Rotax 503 UL / 503 UL DCDI: Subsequent fitting of "C" gearbox

This Service Information refers to all Rotax UL engines type 503 UL and 503 UL DCDI, fan-cooled.

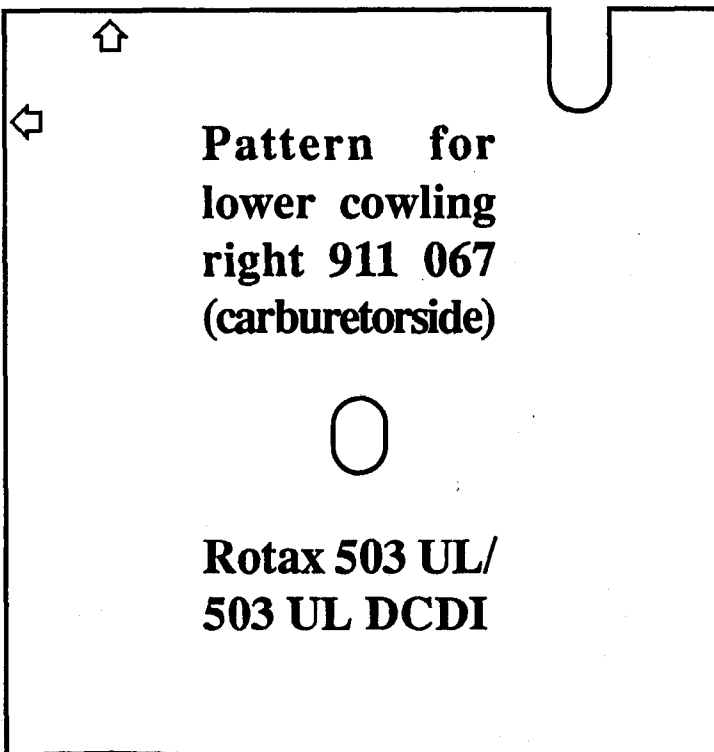
Due to change of „C“-gearbox from sand casting to **permanent mold casting with re-inforced fitting flange** it is necessary to reshape the two cowling lower parts (911 067 and 911 069) in the area of the fitting flange.

**Pattern for
lower cowling
right 911 067
(carburetorside)**

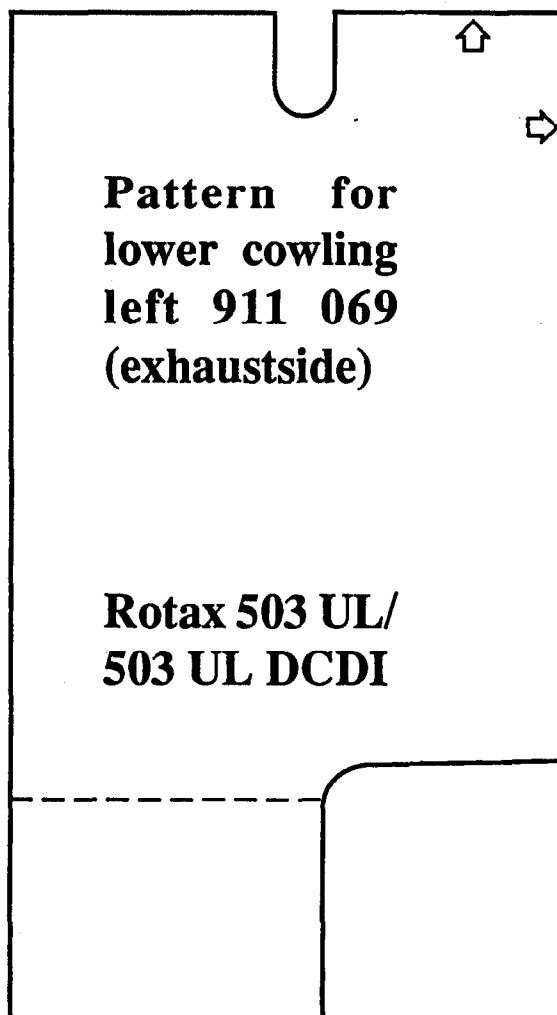
If you wish to fit a „C“ gearbox of permanent mold casting version subsequently to an engine 503 UL or 503 UL DCDI (of a serial number below the one indicated above) you can only fit it after having reshaped the lower cowlings as per pattern enclosed.

- Cut out the pattern or make a pattern of carton.
- Remove lower cowlings from engine.
- Place the respective pattern onto the respective cowling lower part (right side: carburetor side, left side: exhaust side) according to their reference marks  and mark the pattern contour on the cowling with a scribing pin.
- Cut-off at the scribe line.
- Straighten the contour on both cowling lower parts.
- Apply protective paint to the cutting edge.
- Refit cowlings and finish engine mounting.
